MODEL BD-100-1A10 (CH-350)

MODIFICATION – DATALINK SYSTEM – UPGRADE THE DATALINK SYSTEM TO MEET THE EUROCONTROL'S LINK 2000+ REQUIREMENT OPTION (C23-440)

Service Bulletin No.: 350-23-010 **Issue:** Revision 06 **Dated:** Dec 18/2019

SERVICE BULLETIN REVISION TRANSMITTAL SHEET

K1002370003 – Kit – Wiring Diagram – CVR/RIU 1 Wiring for LINK 2000+ (Sheet 2 of 2, Rev. ---)

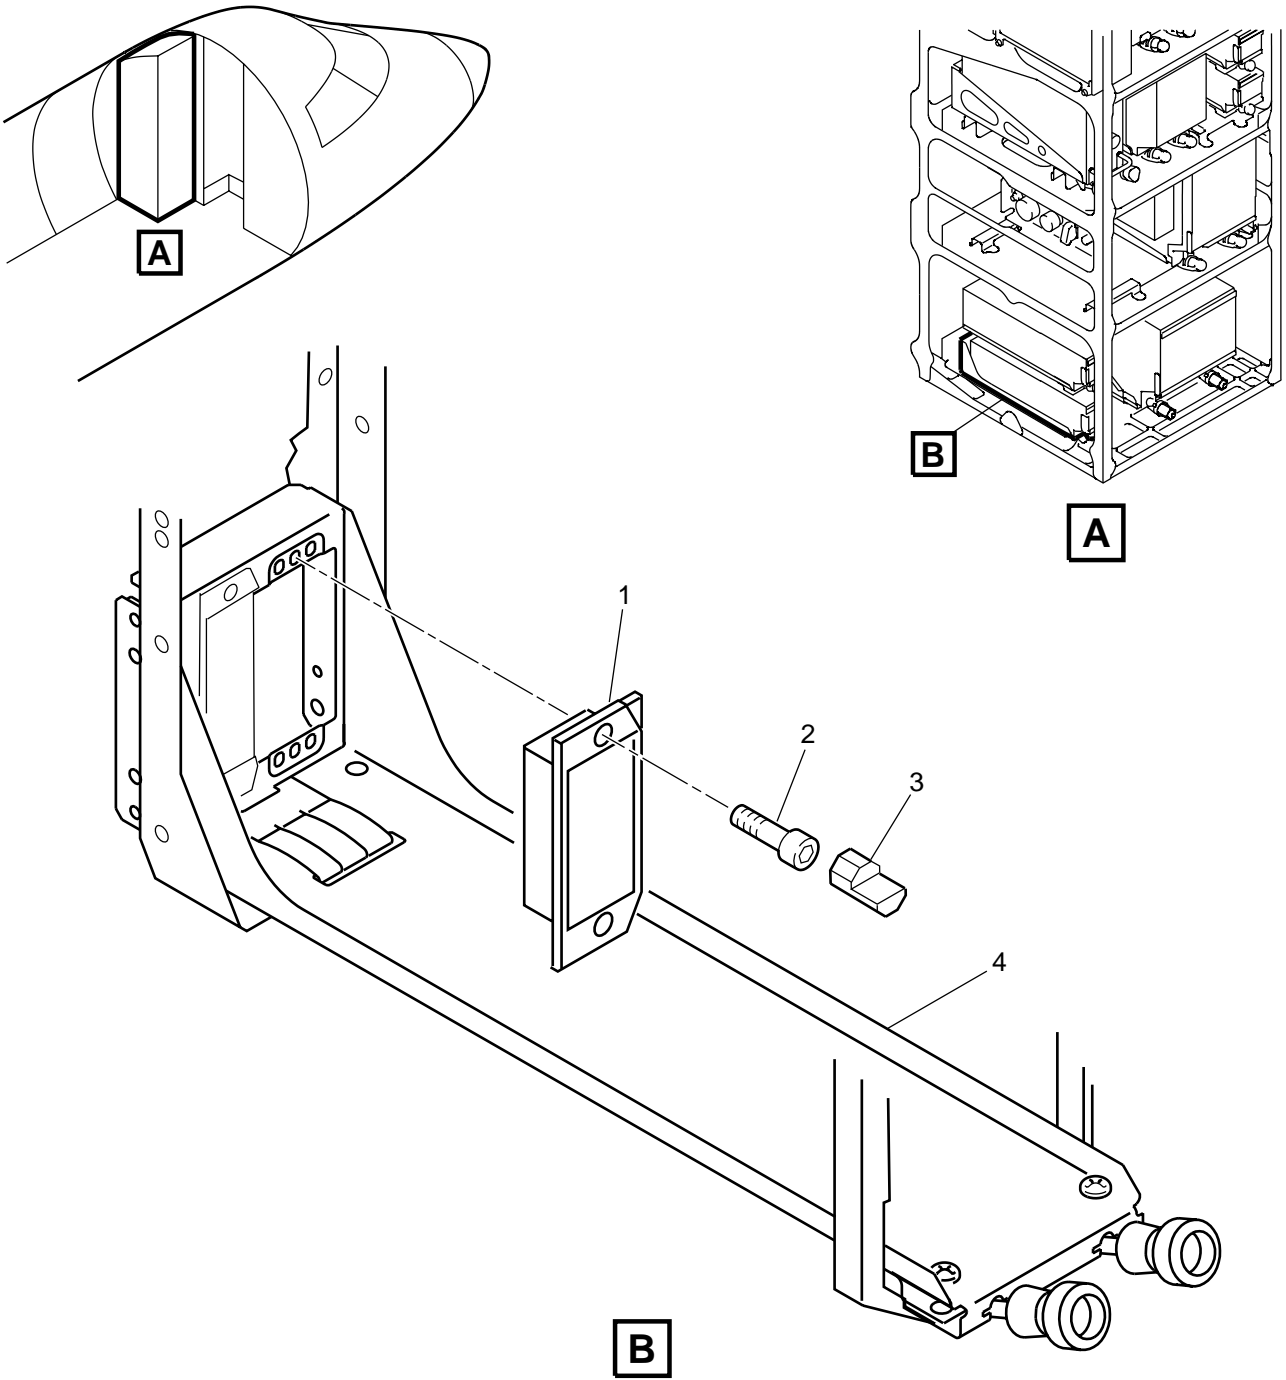
- (iii) Connect wire MAG5675W to pin 5 of RIU 1 connector A17P2.
- (iv) Connect wire MAG5675B to pin 6 of RIU 1 connector A17P2.
- (b) Connect the RIU wiring to the CVR connector A129P1 as follows. Refer to Kit Drawing K1002370003.

- (iv) Connect wire RBG5675W to pin 34 of CVR connector A129P1.
 - (v) Connect wire RBG5675B to pin 33 of CVR connector A129P1.
 - (vi) Trim the conduit, Part No. S10155H23 to the correct length and install on the wire RGB5676N.

- (vii) Install terminal lug Part No. B0808005-006N on wire RBG5676N.
 - (viii) Connect wire RBG5676N to ground stud GS4216, with washer, Part No. AN960JD10L, lockwasher, Part No. MS35338-43 and nut, Part No. MS35650-302. Refer to SPM-MM 51-80-00-910-803.

RIU 1 Connector A17P2 – Removal/Installation
Figure 1

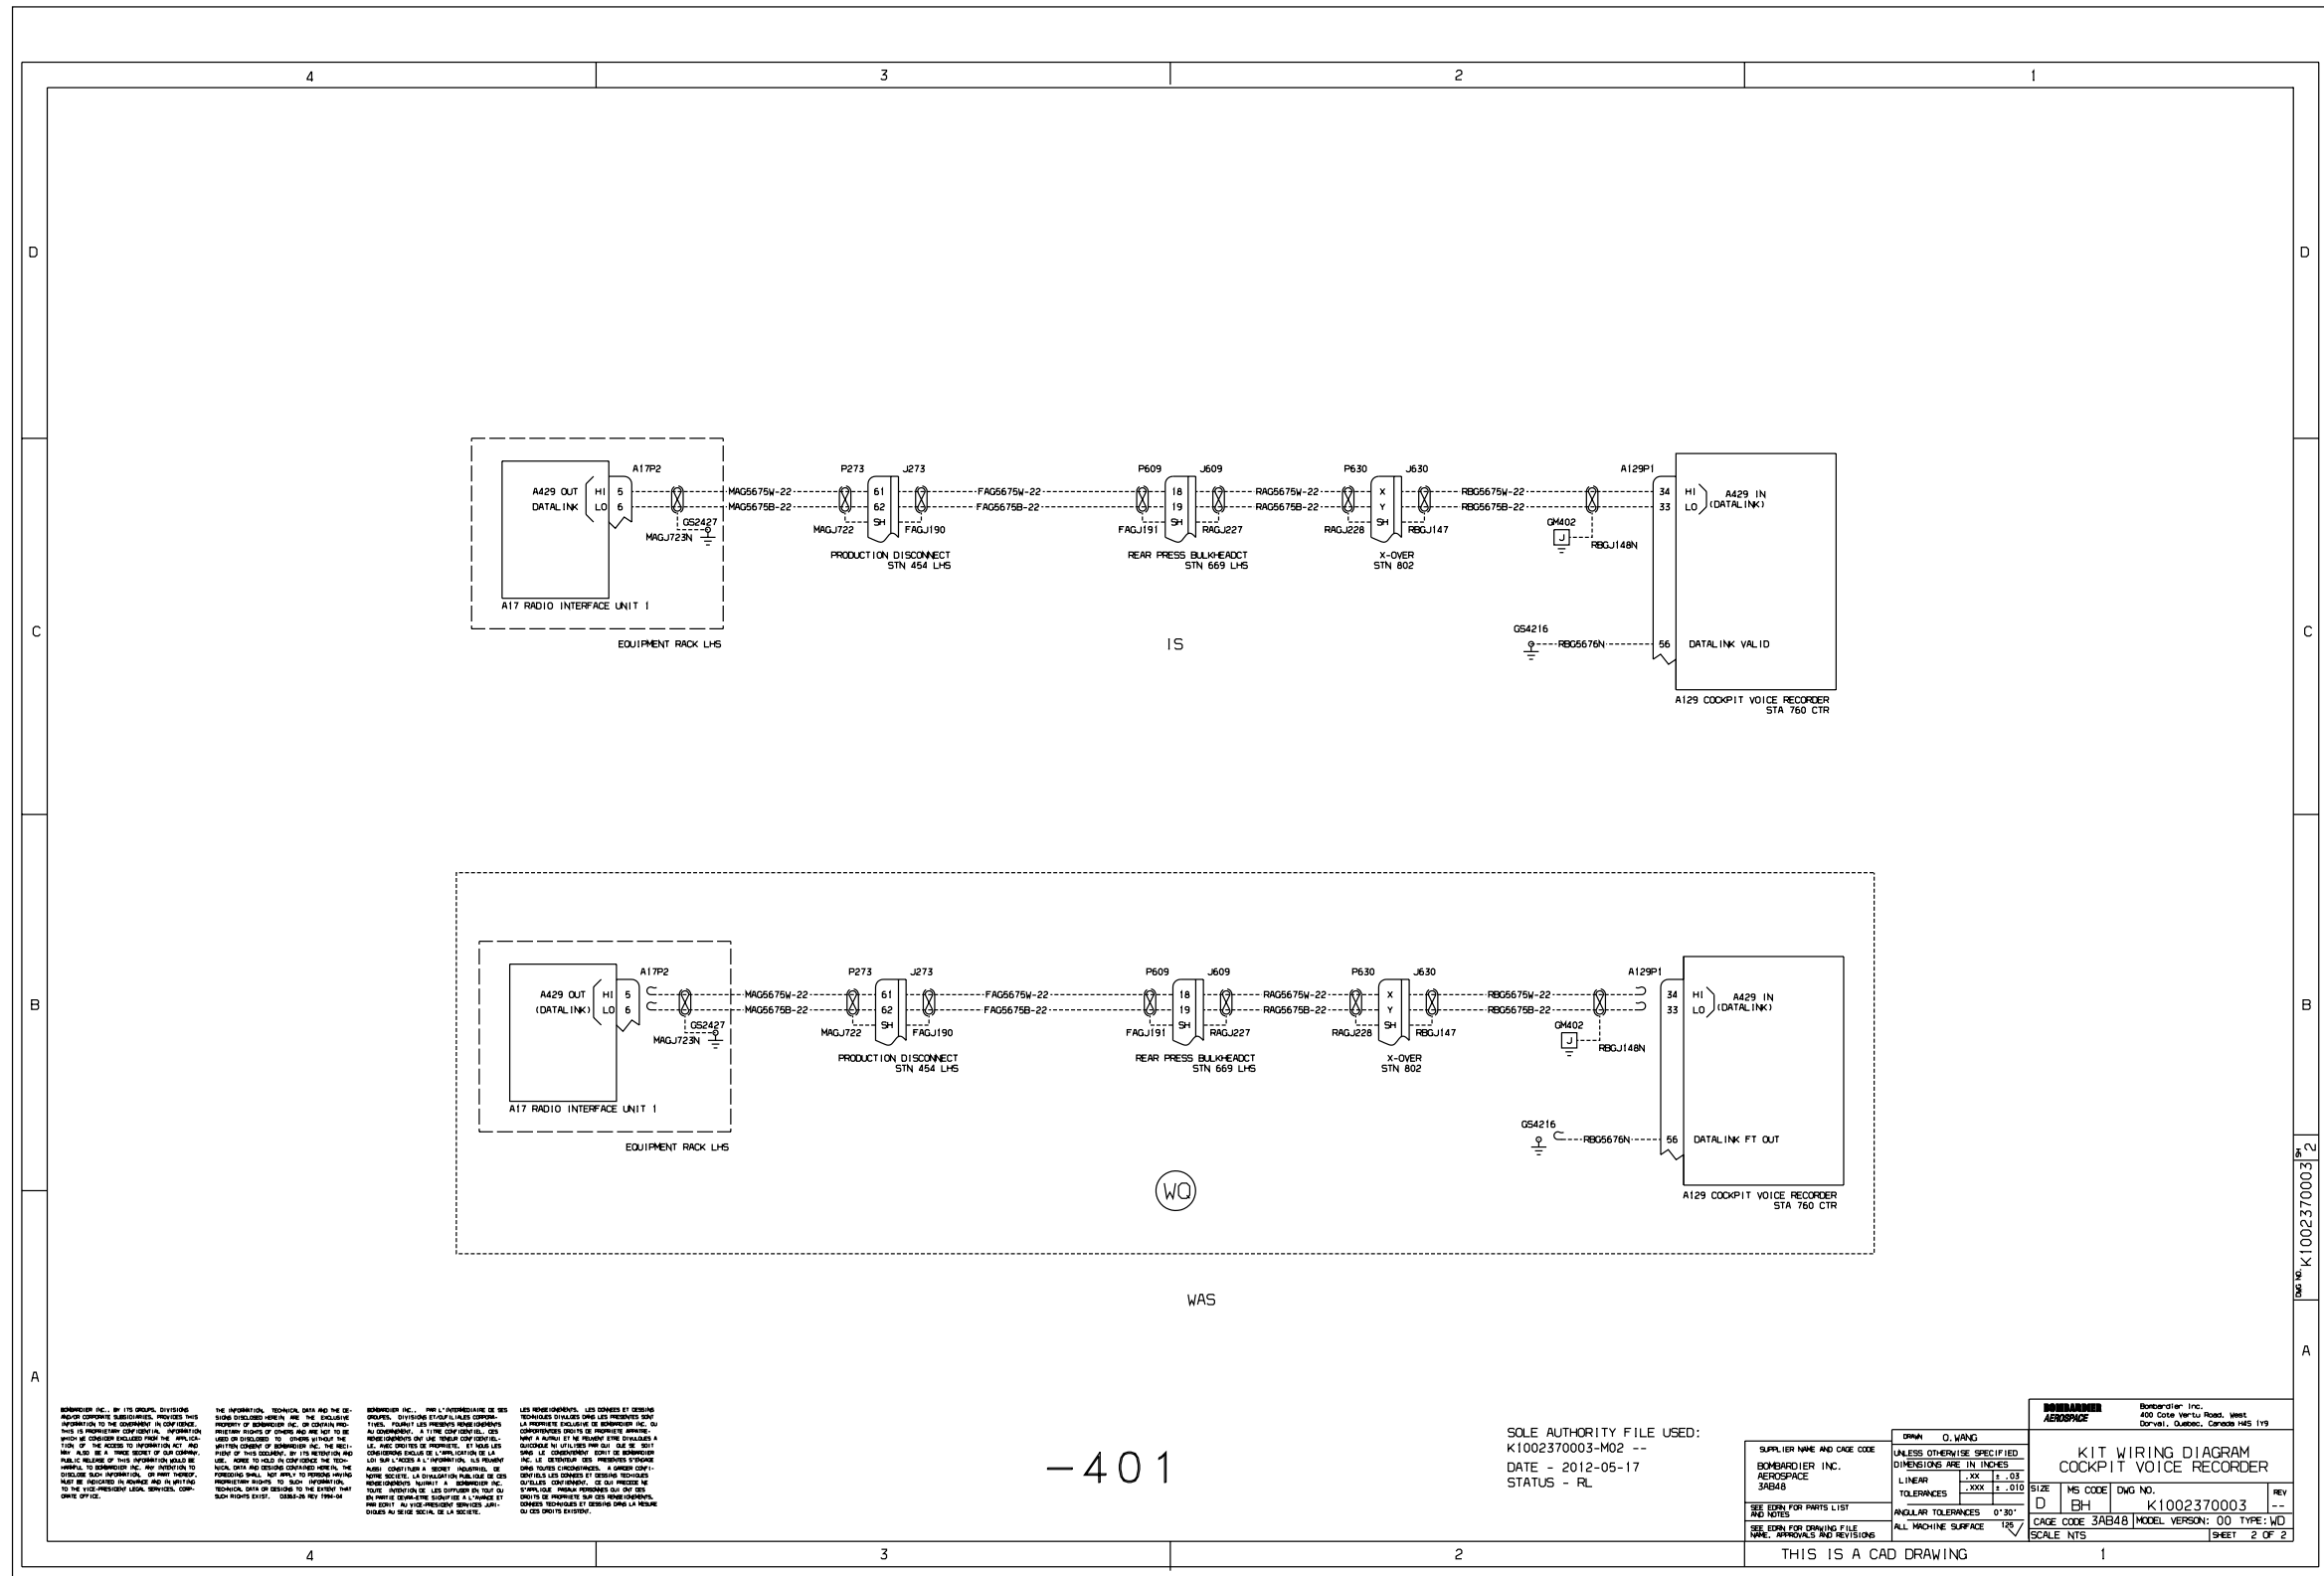
- (1) In the left equipment rack, remove the RIU 1 connector A17P2 (1) from the RIU tray (4) as follows. Refer to Figure 1.
- (a) Remove the RIU 1. Refer to AMM 23-51-21-000-801.
 - (b) Record the position of the indexing key (3) on the connector A17P2 (1).
 - (c) Remove the indexing key (3).
 - (d) Remove the screws (2).
 - (e) Remove the electrical connector A17P2 (1) from the tray (4).
- (2) Connect the CVR to the RIU 1 as follows:
- (a) Connect the CVR wiring to the RIU 1 connector A17P2 as follows. Refer to Kit Drawing K1002370003.
 - (i) Unstow and remove the caps from the wire MAG5675W/B.
 - (ii) Install contacts Part No. 372-2514-110 on wires MAG5675W and MAG5675B. Refer to SPM-WM 20-21-01.

- (3) In the left equipment rack, install the RIU 1 connector A17P2 (1) in the RIU tray (4) as follows. Refer to Figure 1.
 - (a) Put the electrical connector A17P2 (1) in position on the tray (4).

- (b) Install the screws (2).
 - (c) Torque the screws from 13 to 16 lbf in (1.47 to 1.8 Nm). Refer to SPM-MM 20-21-00-910-801.
 - (d) Install the indexing key (3) in the same configuration as recorded during removal.
